CITY PLANNING COMMISSION

APPLICATION:

PROPOSAL: The applicant is requesting the necessary entitlements to develop three warehouse buildings in the Main Avenue Business Park PUD.

APPLC. NO. P90-024 MEETING DATE ~~April 12, 1990~~ ITEM NO. ~~14~~
4-26-90 4

LANDSCAPE PLAN

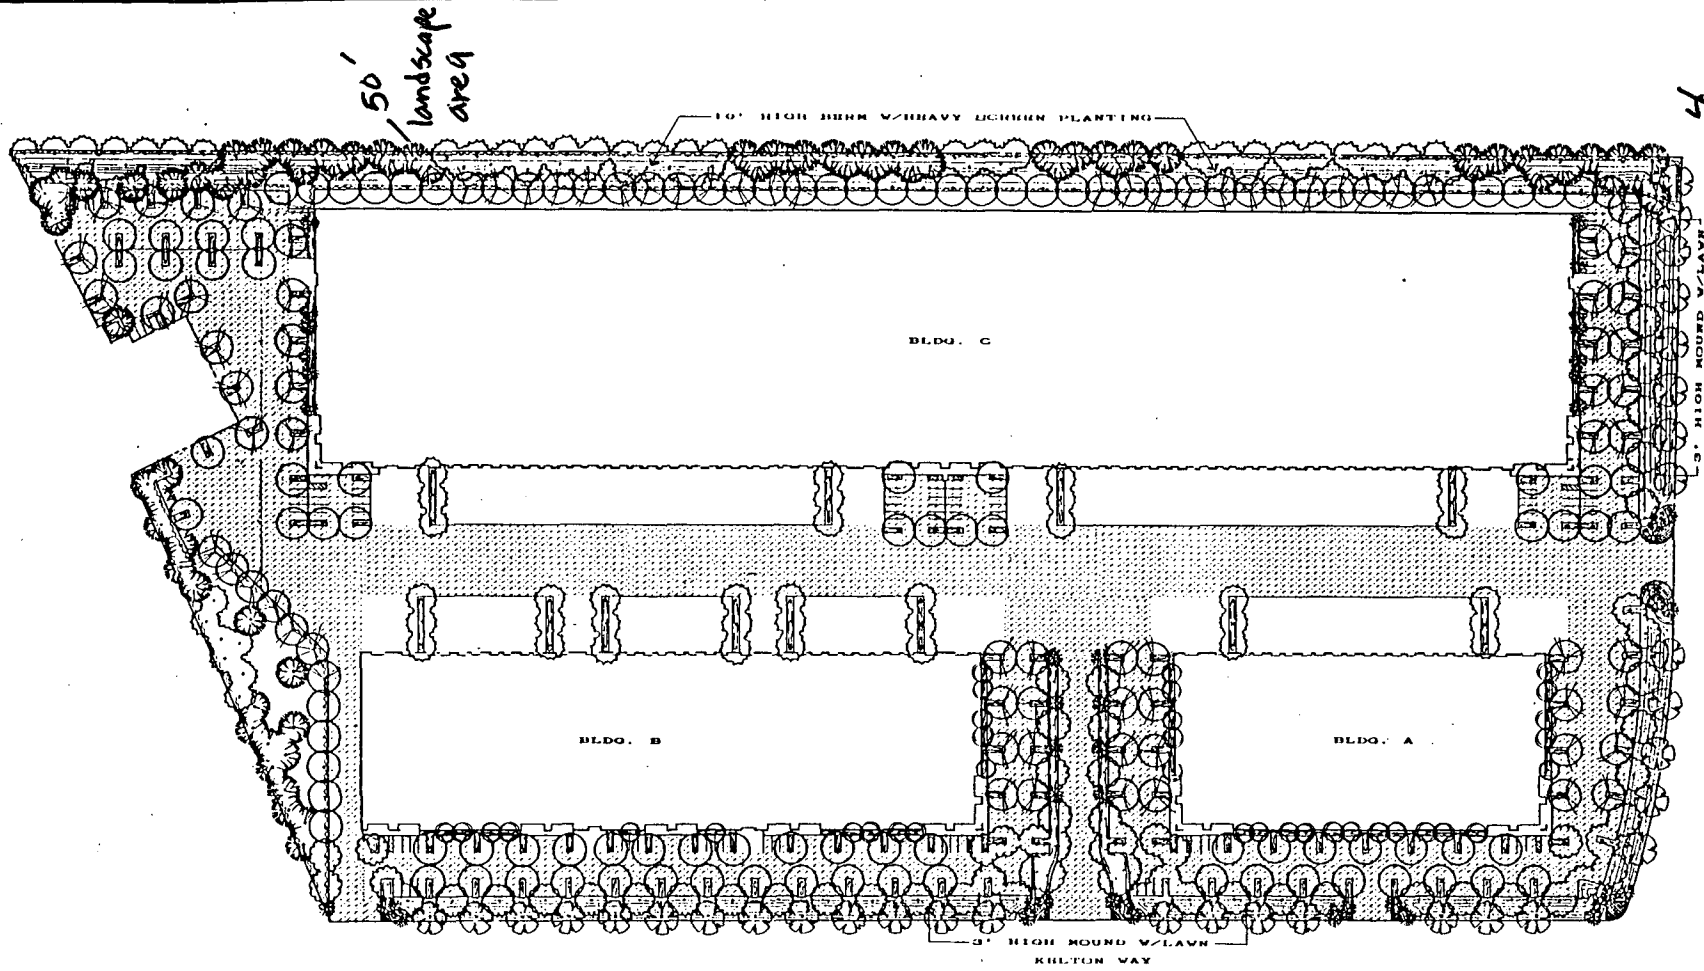
Along the eastern portion of the site, the applicant is requesting to utilize a 50 foot landscape buffer and 10 feet of paved area next to the building as a building setback from the adjacent residential development. The applicant is suggesting this treatment rather than a required masonry wall along the property line. Staff supports the applicant's request. The 60 foot setback will include 50 feet of irrigated landscaping with heavy tree planting and a 10 foot high berm. The submitted landscape plan indicates an exceptionally high number of trees proposed for this 50 foot wide area. Requiring a wall along the property line would essentially result in a double wall situation. The building wall itself will act as a sound wall. Staff is recommending no openings along this rear building area other than man-doors required for fire safety. The City Environmental Division, based on the proposed site design determined that noise impacts on the surrounding residential uses are less than significant and have not recommended any further mitigation measures.

The 15 gallon trees proposed for this area should eventually screen the majority of the building wall from the residential development. The landscape treatment along this eastern portion of the site should be completed prior to occupying of the first building.

- f. wing wall shall be extended from the southern ends of buildings A and C to providing screening to Main Avenue.
3. The submitted landscaping plan shall be revised to present a detailed design for the eastern 50 foot landscape area. This detailed plan shall be in addition to the submitted plan.
